RE: Determine Completeness  
High Point Estates, of Adams Road Co.

### **Determination of Completeness of the Subdivision**

Re: High Point Estates: Request for Determination of Completeness of the  
Subdivision.

**Subject: High Point Estates (Adams Road Trust)  
Review of Draft As-Built Plans**

DATE	DEC. 15, 2016	PROJECT NO.	649-1-03	SHEET 1 OF 10
REVISIONS	SEPT. 24, 2019			
	JAN. 28, 2020

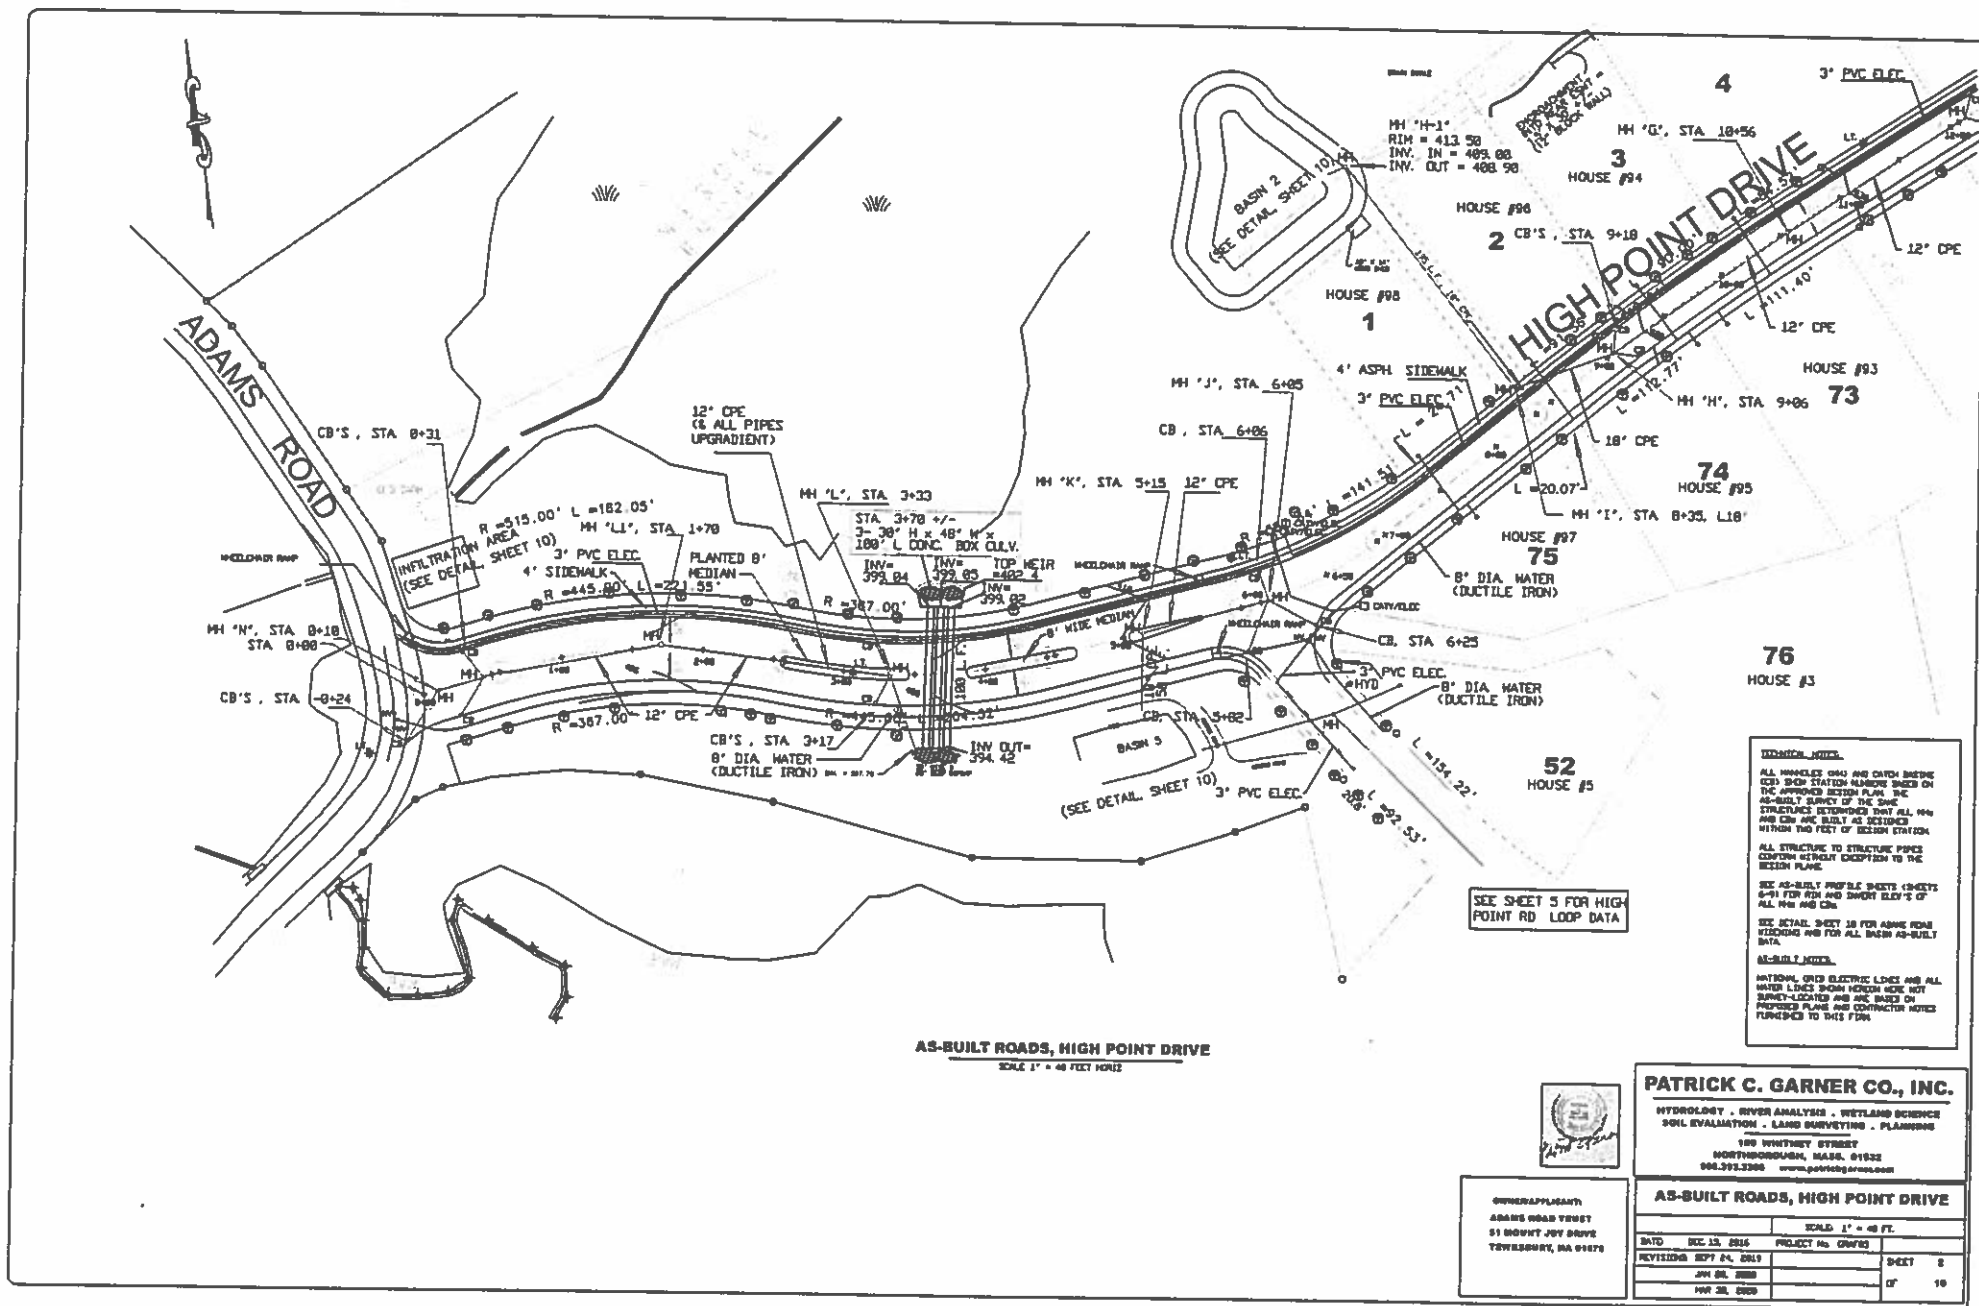
6. The as-built plans must be revised to include spillway elevations for Basin 1, Basin 2, Basin 4, Basin 5 and the Rear Detention Basin.
7. On Sheet 1 at the north side of the property along the chain link fence that abuts the Massachusetts Turnpike, the line whose bearing is "S81°34'59.51"E" appears to have an incorrect length label of "1473.78". Also, the boundary point on the west end of this line needs to be labeled.

8. On Sheet 1, along the front property line for Lot 61 there is a distance labeled "96.12". This distance does not appear to be correct (based upon scaling of the submitted draft as-built plan). The plans must be revised accordingly.

9. On Sheet 1, the following bearings and distances were missing but need to be provided. The plans must include all bearings and distances.
  - a. The bearing and distance for property line that borders Westborough (roughly 210 feet long).

10. On Sheet 1, the drain easements at the rear of Lots 41, 42, 43, 44 and 45 were not shown. On the construction plans, these easements were originally ten feet wide. The easement on Lot 41 was further revised by way of a construction plan last revised August 5, 2008 to be 25 feet wide as measured from the southern property line and at various widths up to approximately 50 feet wide as measured from the western property line. Similarly, on Sheet 10 the ten-foot wide easements at the rear of Lots 42 and 43 were not shown on the "Detail of Swale & Rear Detention Basin" inset; these easements are needed to allow access around the stormwater swale that is now located within the Open Space. Also, potential access from the Winterberry Court common driveway easement needs to be addressed. Based upon construction plans last revised August 5, 2008, we understand that the access and utility easement was extended to Winterberry Court. Neither Sheet 1 nor Sheet 10 show this easement to Winterberry Court. However, physical access may exist from Pepperbush Court via the "Tot Lot".

11. On Sheet 1, the drain easement along the southern side of Lots 34, 40 and 41 was labeled as "20' Drain Easement" but was drawn as being ten feet wide. We understand that the easement was intended to be a ten (10) foot wide drain easement. The drain easement's label must be revised.

12. On Sheet 1, the drain easement at the rear of Lots 2 - 4 was labeled as being 20 feet wide but is actually 25 feet wide; the label needs to be revised.

ADL | Sheet 2 -- Graf Roads subd 330. 2000. ylf (1) ru

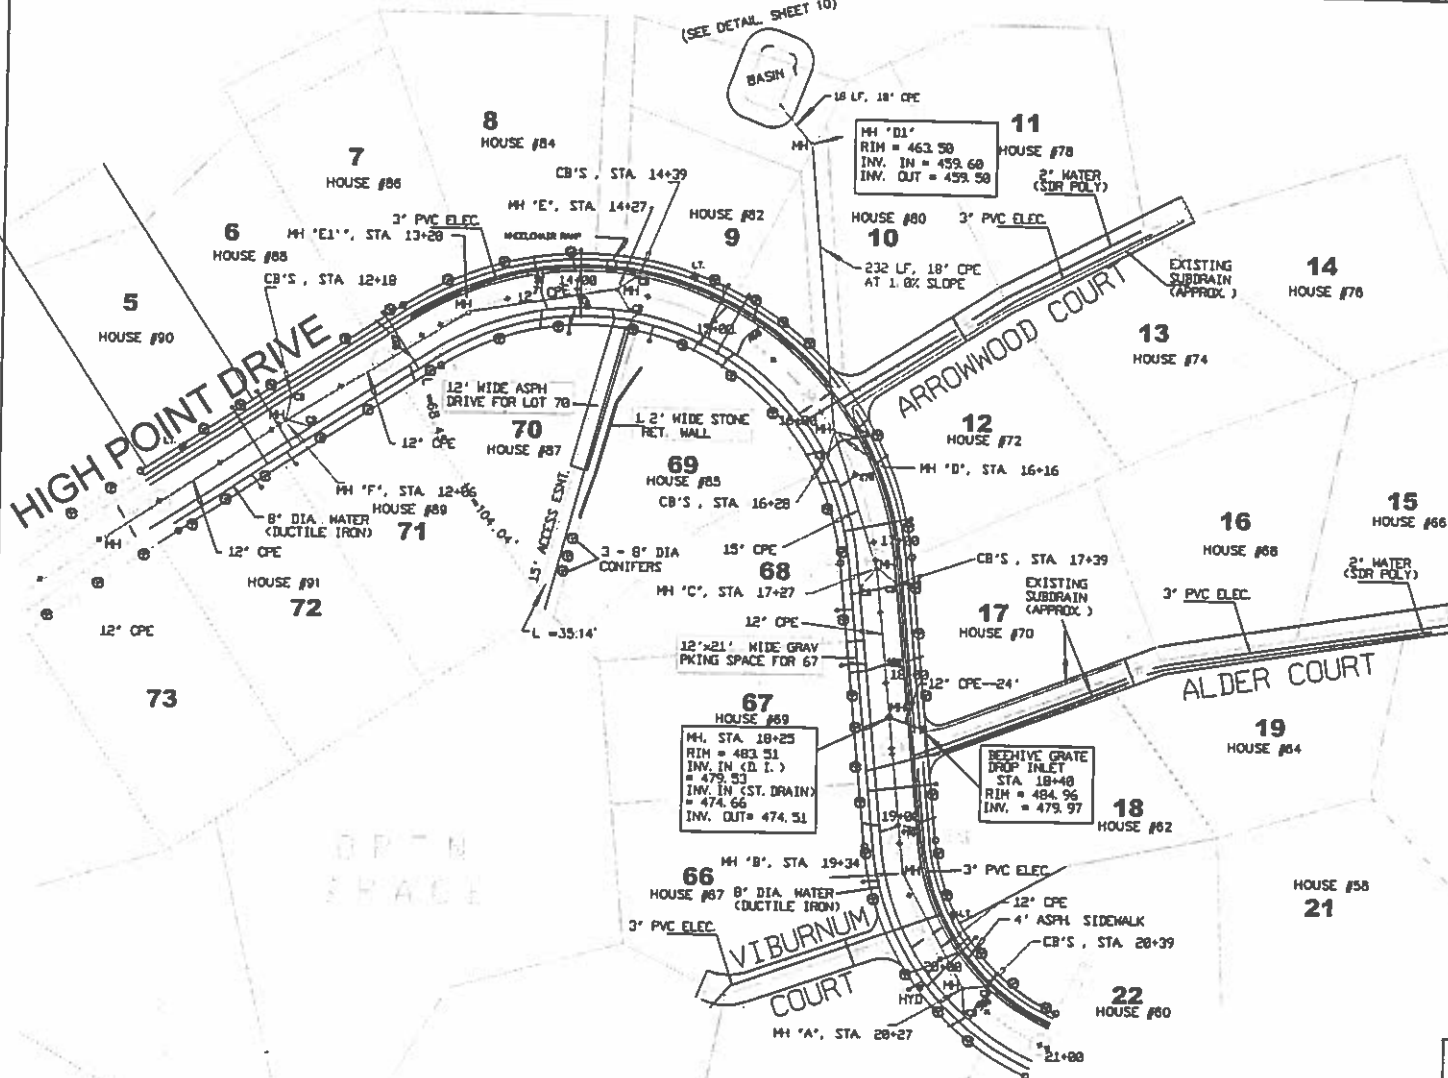
13. On Sheet 2, elevations need to be shown for the inlet inverts of the triple box culverts and for the inlet weir crest.
14. On Sheets 3 and 4, the lines for the sidewalks need to be deleted where the sidewalks cross the paved portions of the common driveways.

The lights were shown as originally proposed and don't account for changes to light pole locations during construction. On Sheet 2, the light at the southeast corner of the intersection of Adams Road and High Point Drive is in the wrong location; the light was installed on a utility on the west side of the intersection. The lights shown at Lots 23, 45 and 51 are not present in those locations and a light is missing from the vicinity of Lot 47.

The light poles have been revised to reflect present conditions except on Sheet 2. The light pole was relocated on the plan. However, the light is now shown at the northeast corner of the intersection of Adams Road and High Point Drive; a light is only located on a utility on the west side of the intersection. Furthermore, on Sheet 10 in the inset for "Expanded Adams Rd Width" two streetlights are shown on the east side of the intersection where streetlights weren't installed.

**Acknowledged. Sheets 2 and 10 were revised accordingly.**

AS-BUILT ROADS, HIGH POINT DRIVE			
DATE	DEC 23, 2004	PROJECT No.	040708
REVISIONS	SEP 24, 2011		
	JUN 20, 2009		
	MAY 20, 2009		
		SHEET	3
		OF	10

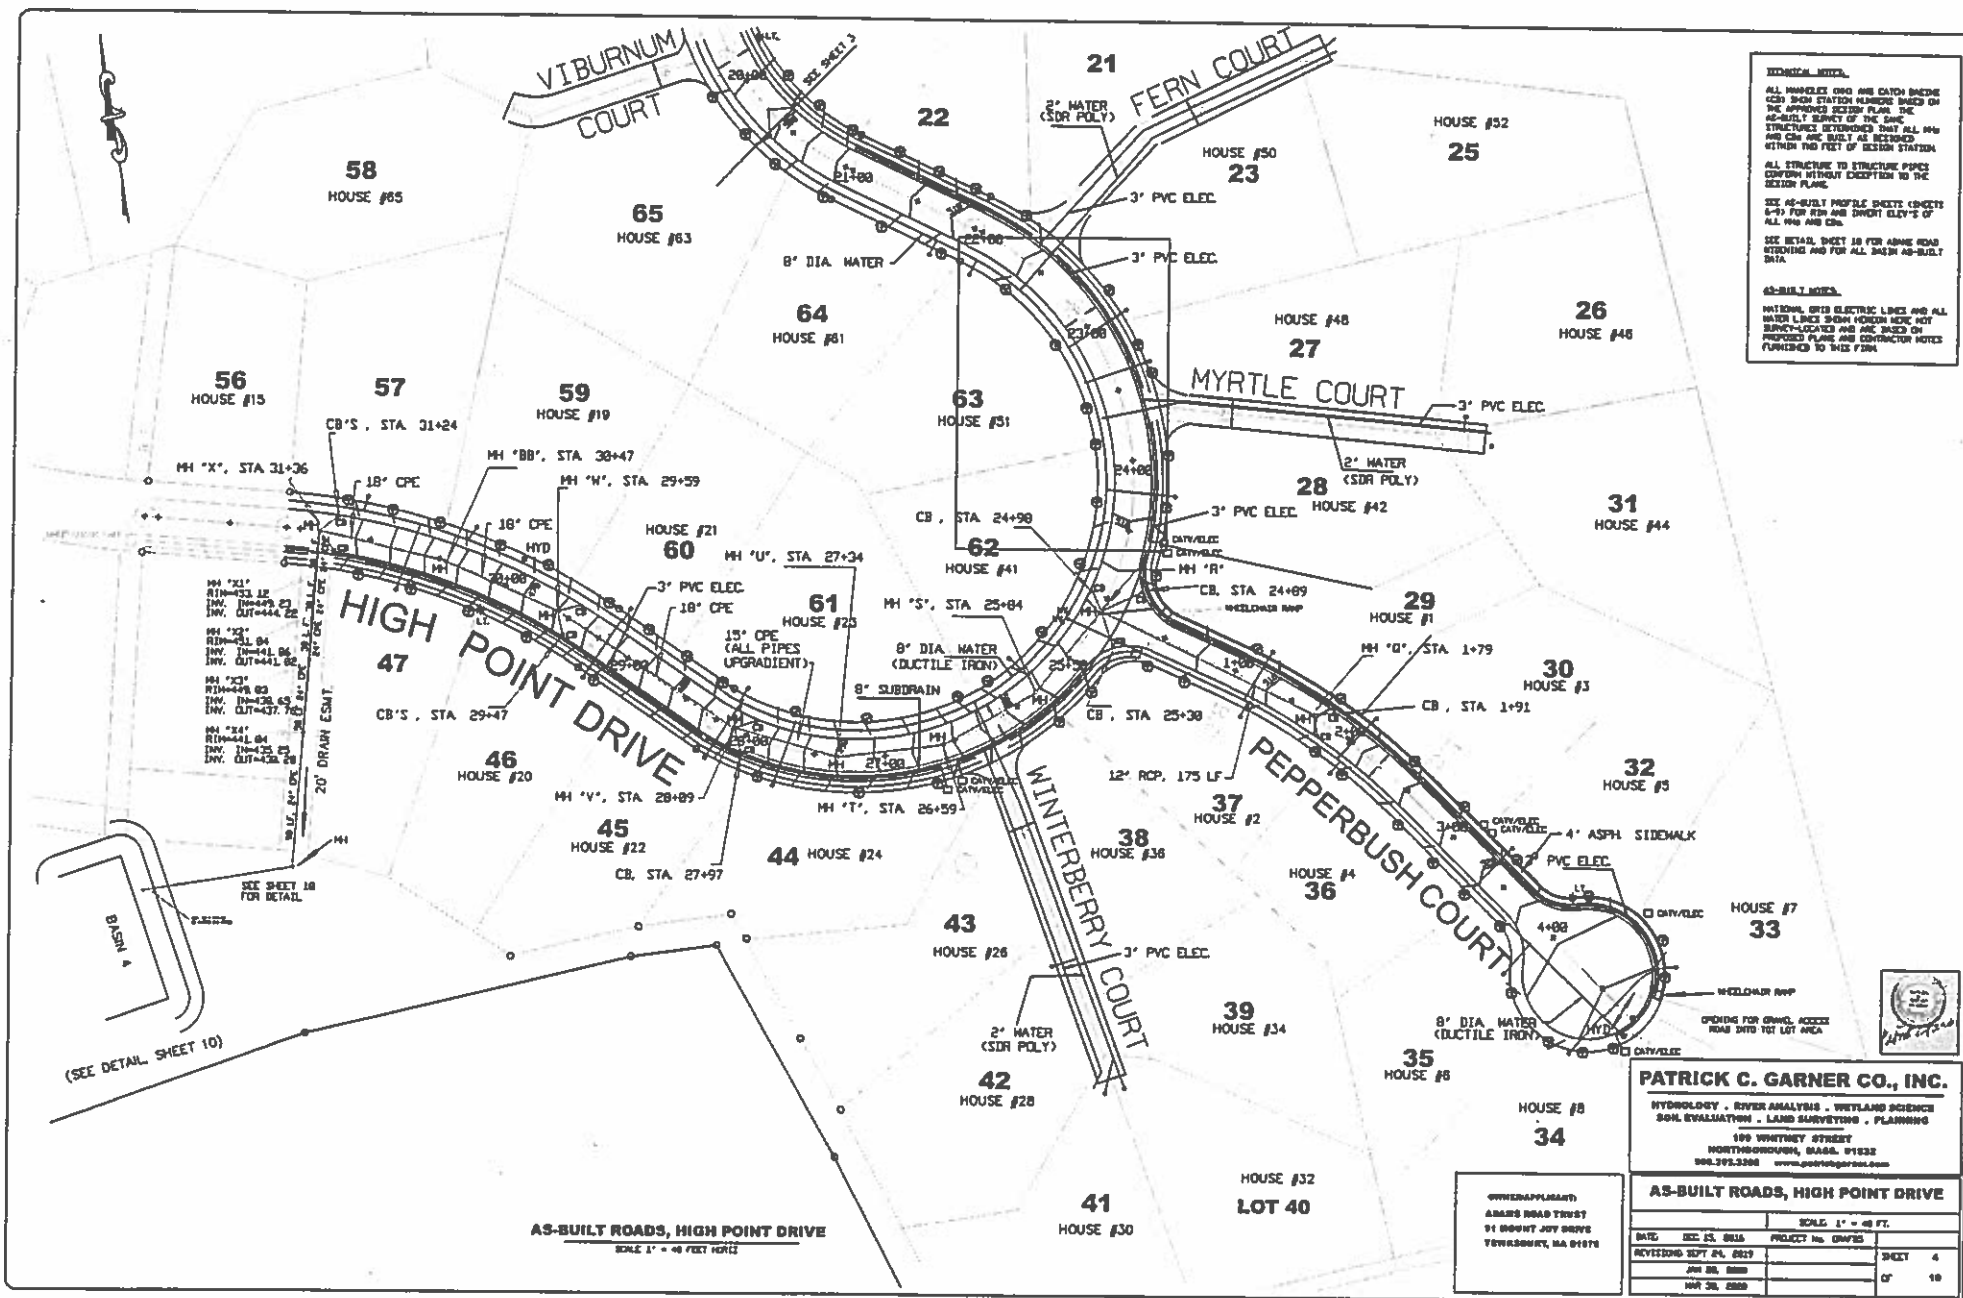
*The valves and subdrains were added to the plans. However, the waterline pipe material is still missing and house numbers on Sheets 3 - 5 are incomplete (e.g. see Lots 18, 19, 20, 39 - 43, 52).*

- The contours need to be adequately labeled; there is only one contour label on Sheet 3 (near station 13+80).  
**Acknowledged. Contour labels were added.**

**Acknowledged.** Sheets 3 – 5 were revised to include the above-referenced information.

102/ Sheet 4b -- Grp roads Subd. 3-30-20. pfg (1/24)

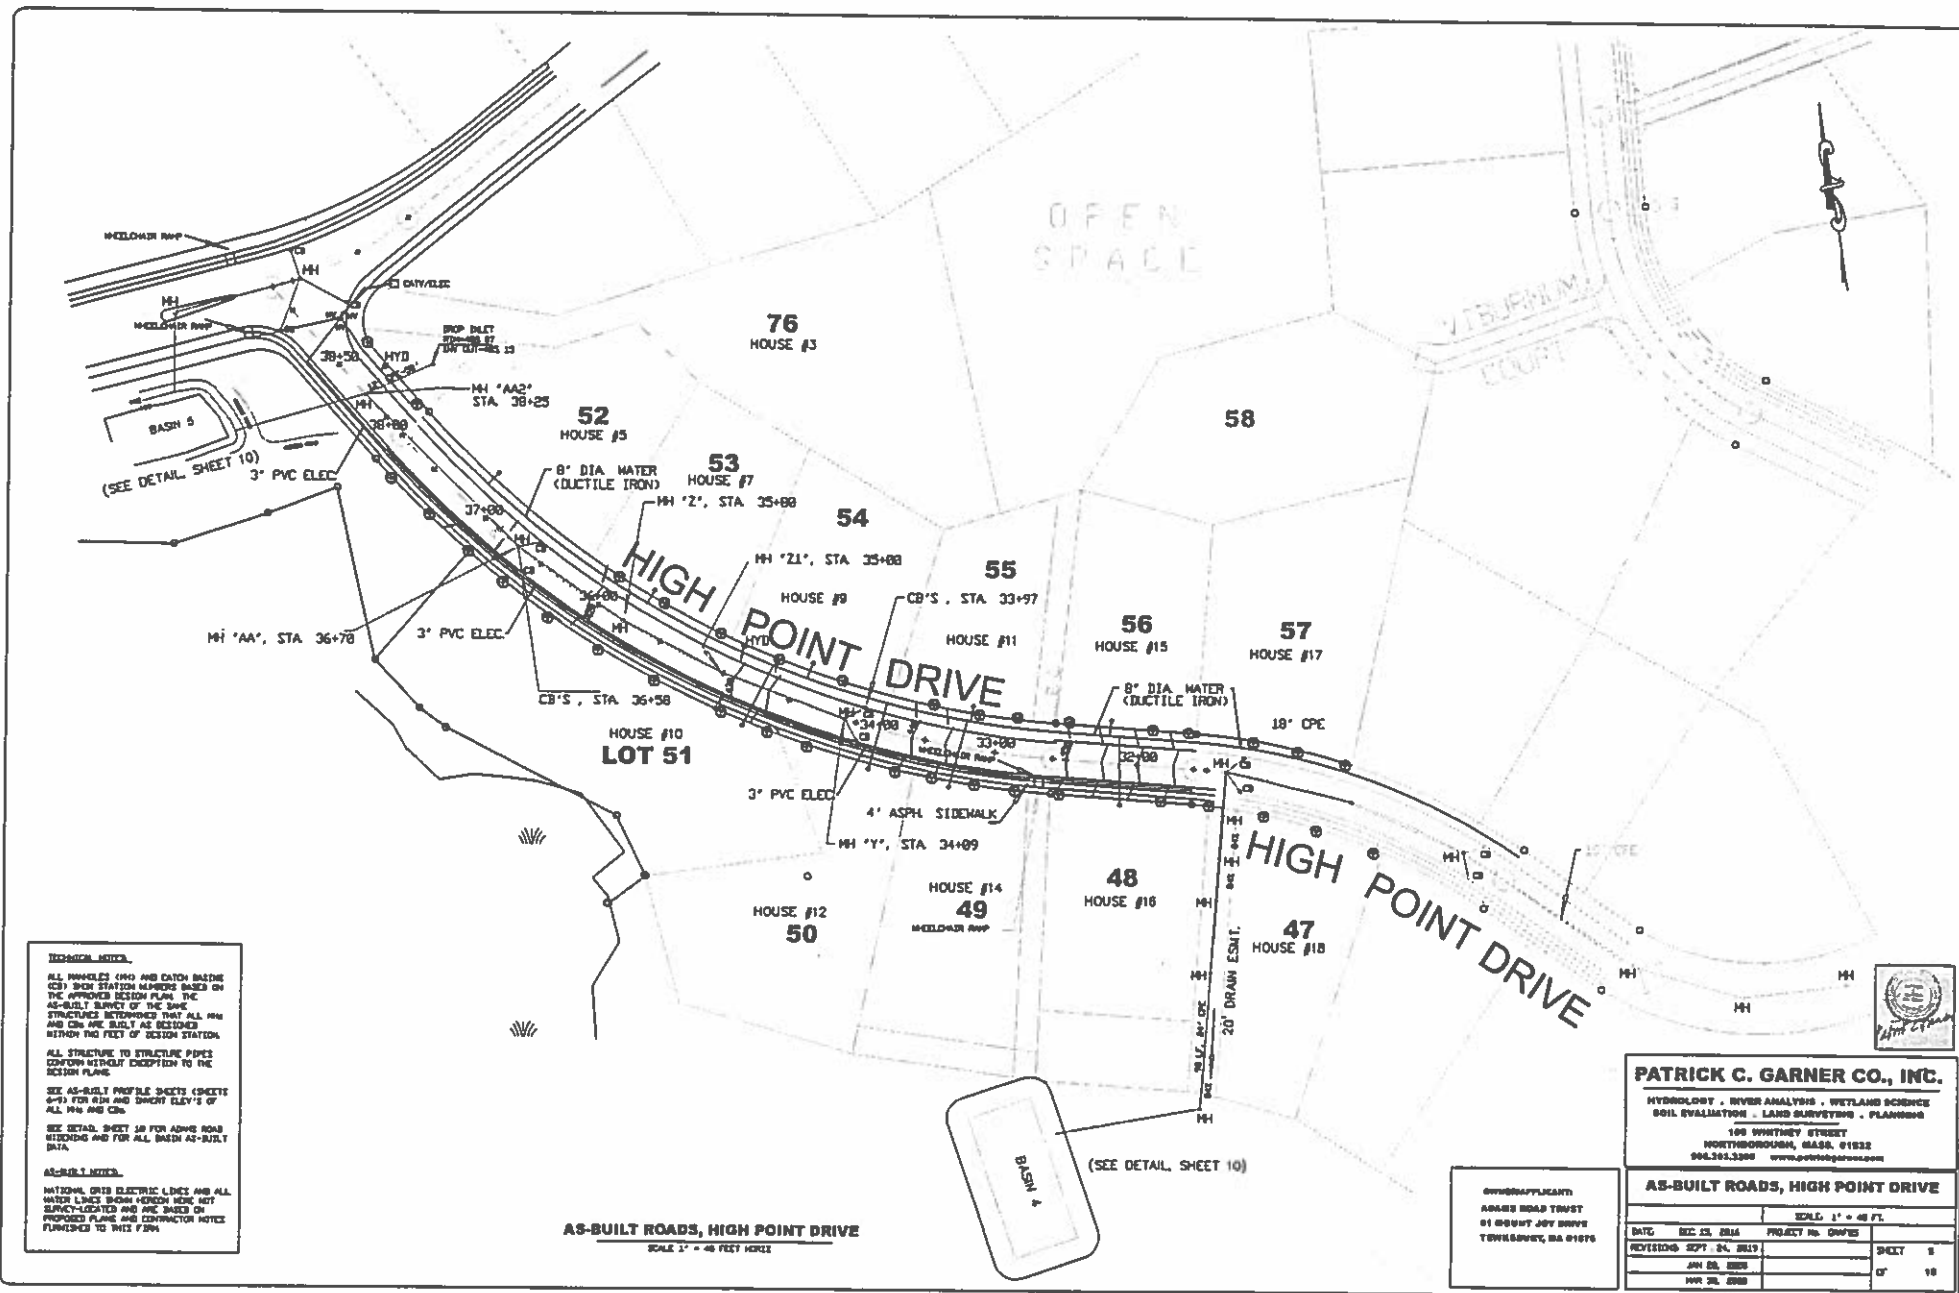
15. On Sheet 4 the rim of "MHX1" was labeled as "Rim=4453.12". This appears to be a typographical error but must be revised nonetheless.
16. On Sheet 5, the drop inlet that was installed on Lot 52 and connected to drain manhole "AA2" and its connecting pipe need to be shown on the plan along with pertinent information (e.g. elevations, pipe slope, pipe diameter).

- On Sheet 4, the contour at station 28+60+/- was labelled "480" but by working down from the 490 contour at station 27+50+/-, the "480" label should be "482".

**Acknowledged. The contours and labels between stations 26+00 and 30+00 were revised.**
  - Any elevation labels need to clearly identify the contour to which they're associated. On Sheet 4, at station 22+20+/- there is a "510" elevation label but no contour nearby.
